REQUEST

Current Zoning: R-3 (single family residential)
Proposed Zoning: UR-1(CD) (urban residential, conditional)

Approximately 7.69 acres located on the west side of Steele Creek Road, south of Hamilton Road.
(Outside City Limits)

The petition proposes to allow a new 32-unit townhouse community on land with single family homes and vacant acreage in southwest Charlotte at a density of 4.2 dwellings per acre.

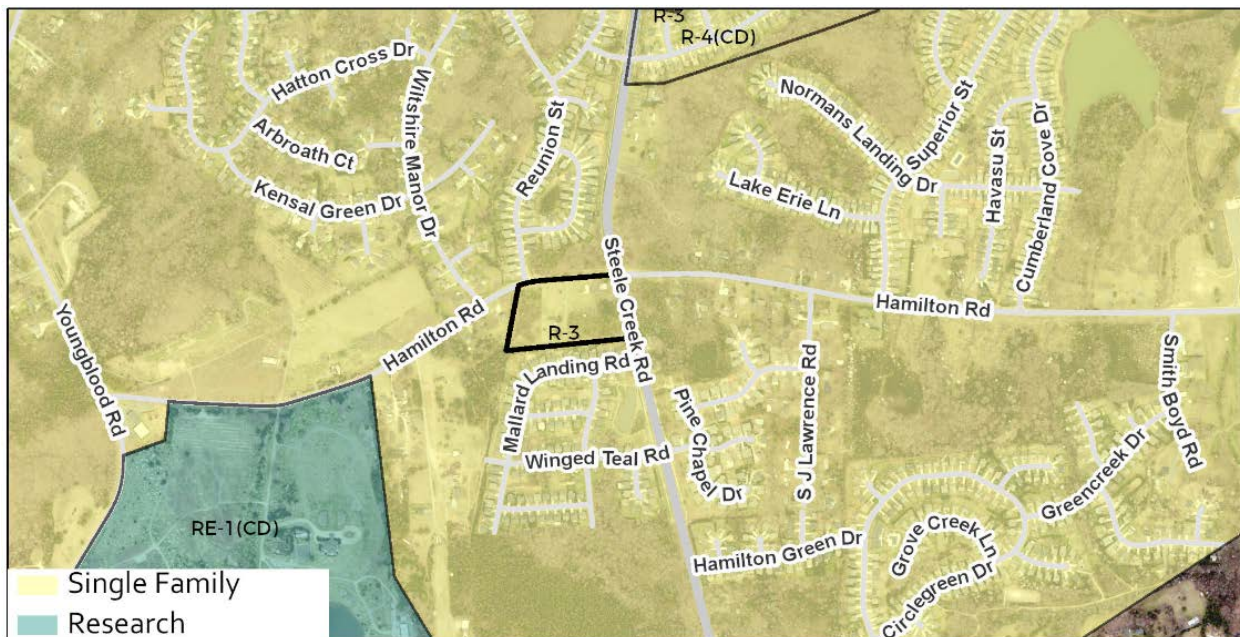
- Up to 32 townhomes at a density of 4.2 units per acre.
- Maximum building height of ~~48~~ 40 feet.
- Provides 30-foot setbacks along Hamilton Road and Steele Creek Road, which is larger than the 14-foot required setback.
- Proposes 42-foot Class C buffer along property lines abutting single family residential zoning and/or use.

- **TRANSPORTATION CONSIDERATIONS**
 - The site plan has committed to pedestrian improvements in the form of a 12-foot multi-use path. In addition, the site plan has committed to dedicating right-of-way for the NC DOT NC 160 widening project. However, CDOT continues to request the site plan to reflect recent curb and gutter, and multi-use path location changes to the NC 160 project.

1. ~~The proposed zoning district has a setback measured from back of the existing or proposed future curbline. The proposed cross section for the NCDOT widening project U-5766 has been updated. Based on the new cross section, the location of the future back-of-curb for:~~ Addressed

- a. ~~Steele Creek Road — 42 feet from centerline of the road (reduced from 53 feet)~~
 - b. ~~Hamilton Road — 20.5 feet from centerline of the road (reduced from 28 feet)~~

2. ~~Revise the site plan to show:~~
 - a. ~~The back of multi-use path on Steele Creek Road located 65.5 feet from centerline of the road.~~ Addressed
 - b. ~~The back of multi-use path on Hamilton Road located 40.5 feet from centerline of the road.~~

3. ~~The right-of-way for Steele Creek Road is shown incorrectly on the updated site plan. Furthermore, the updated cross-section for the NCDOT widening project U-5766 has changed the right-of-way. The petitioner should revise the site plan and conditional notes to show the dedication of right-of-way, fee simple, of 66 feet from centerline of Steele Creek Road (reduced from 75 feet).~~ Addressed

4. ~~Revise the site plan to show the correct existing right-of-way on Hamilton Road of 60 feet wide total, 30 feet from centerline of the road.~~ Addressed

5. ~~Reduce the building height to no greater than 40 feet so as to be in character with nearby single family residential neighborhoods.~~ Addressed
